DEFENSE NUCLEAR FACILITIES SAFETY BOARD

Staff Issue Report

SUBJECT: Design Basis Earthquake Ground Motion Criteria for the Hanford Site and Waste Treatment Plant

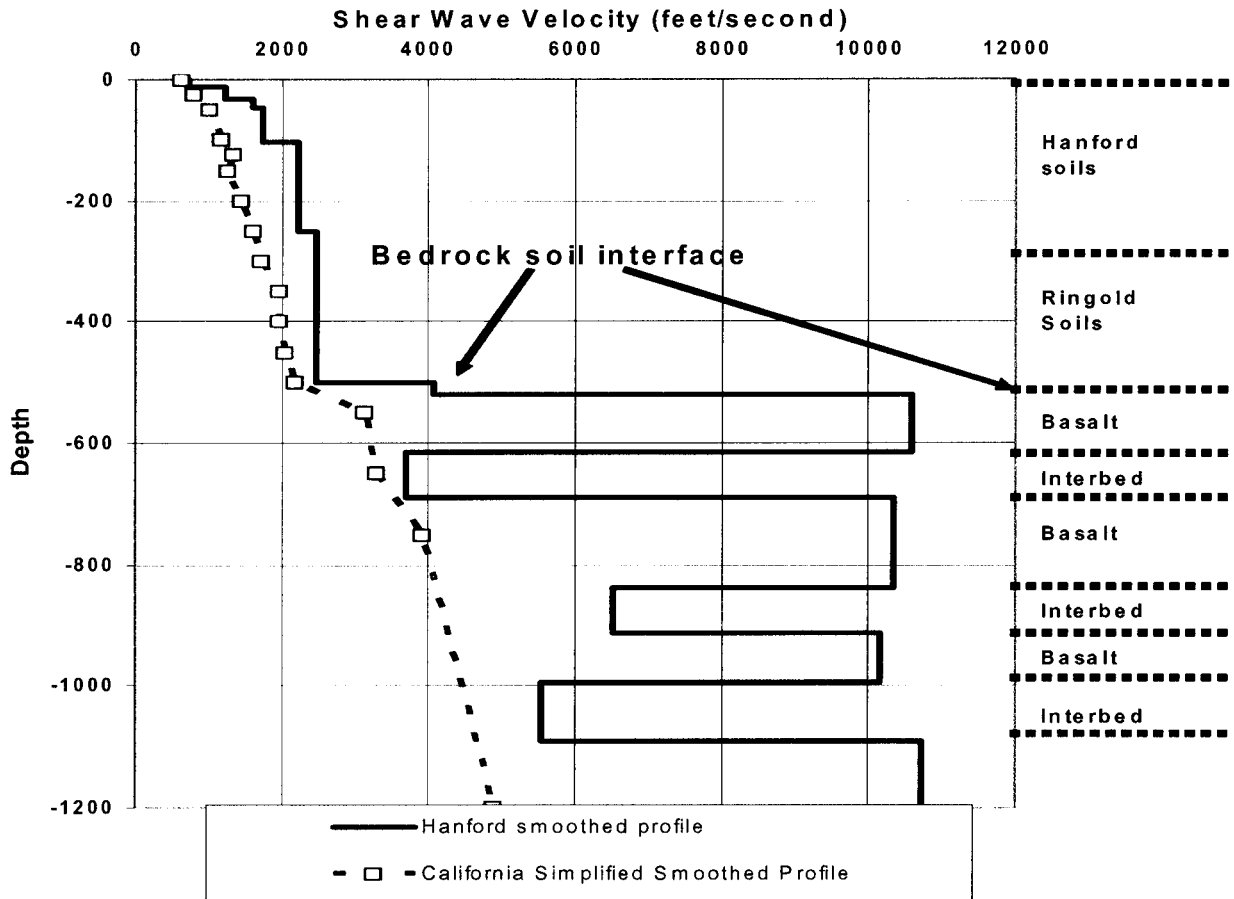
The Board's staff developed Figure 1 from these site response analyses to illustrate the V_s profile for California and the V_s profile used for the Hanford site. It is important to note that the Hanford bedrock V_s profile shown in Figure 1 is based on velocity data taken ~20 km from the WTP site.

In general, the potential for ground motion amplification is enhanced when large impedance contrasts exist, such as when a high Vs bedrock material underlies a low Vs soil material. The magnitude of amplification depends on the thickness and damping characteristics of the overlying soils. As such, the large impedance contrast at the bedrock soil interface seen in Figure 1 should result in more ground motion amplification through the soil for Hanford relative to California. This point was demonstrated in the 1996 Probabilistic Seismic Hazard Analysis through limited sensitivity studies that showed the site response at Hanford being as much as 50 percent greater than that of California if the bedrock is assumed to be one continuous unit (i.e., all basalt).

However, the Hanford bedrock is not continuous, as seen by the bedrock interbeds shown in Figure 1. The 1996 analysis predicted a significant energy reduction resulting from the arrangement of these bedrock interbeds. This energy reduction counteracted the large soil amplification, resulting in comparable ground motion for Hanford relative to California. Thus the behavior of the bedrock interbeds plays a critical role in determining the site ground motion.

Early assessments conducted by the Board's staff estimated that the site response at Hanford could be about 15 percent greater than that at California sites in the frequency range of 4 to 10 hertz. This was communicated to DOE in the Board's letter of January 21, 2003. However, differences in the characterization of the soils and bedrock at the WTP site could have a significant impact on the difference between the WTP site response and that at California sites. While it may be expected that ground motion changes of up to 15 percent can be addressed by implementing acceptably conservative compensatory design features (e.g., demand/capacity ratio ≤ 0.85), the same might not be the case if the ground motion were to increase by as much as 50 percent. Thus understanding Vs for the WTP site soil, basalt, and interbeds is essential.
